**ADDENDUM NUMBER 1**

**CITY OF LEMOORE**

**INDUSTRIAL PARK DEVELOPMENT**  
**PHASE 1 & PHASE 2**

**May 15, 2020**

STD.  
NO.  
M-8

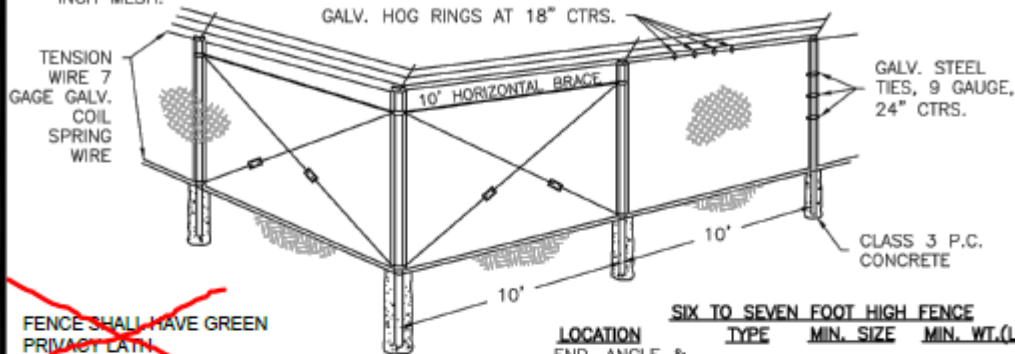
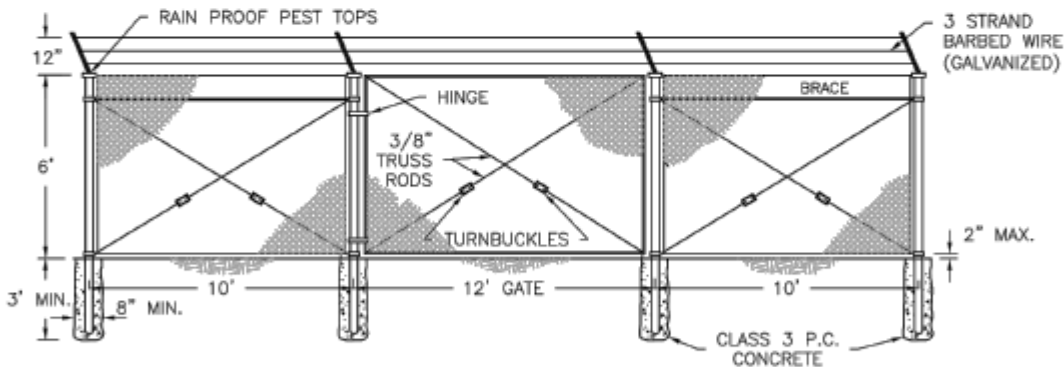
#### **ITEM No. 1 CHAIN LINK FENCE GREEN PRIVACY LATH (SHEET 47):**

- City Standard shown on the plans (Sheet 47) has been revised to exclude the Green Privacy Lath.

**Q1:** Specs pg. 21 - refers to city drawing M-12 with 11 ga mesh, (dated 2003), and detail on sheet 47 includes M-8 (dated 2019) with 9 ga mesh, both with 1 1/2" mesh size. Would a 9ga 3x5" mesh with pre-inserted privacy slats be a suitable alternative?

~~FENCE SHALL HAVE GREEN PRIVACY LATH.~~

**A1:** No. The plans have been revised to remove the Privacy Green lath. Chain Link fence shall conform to City Standard M-8.
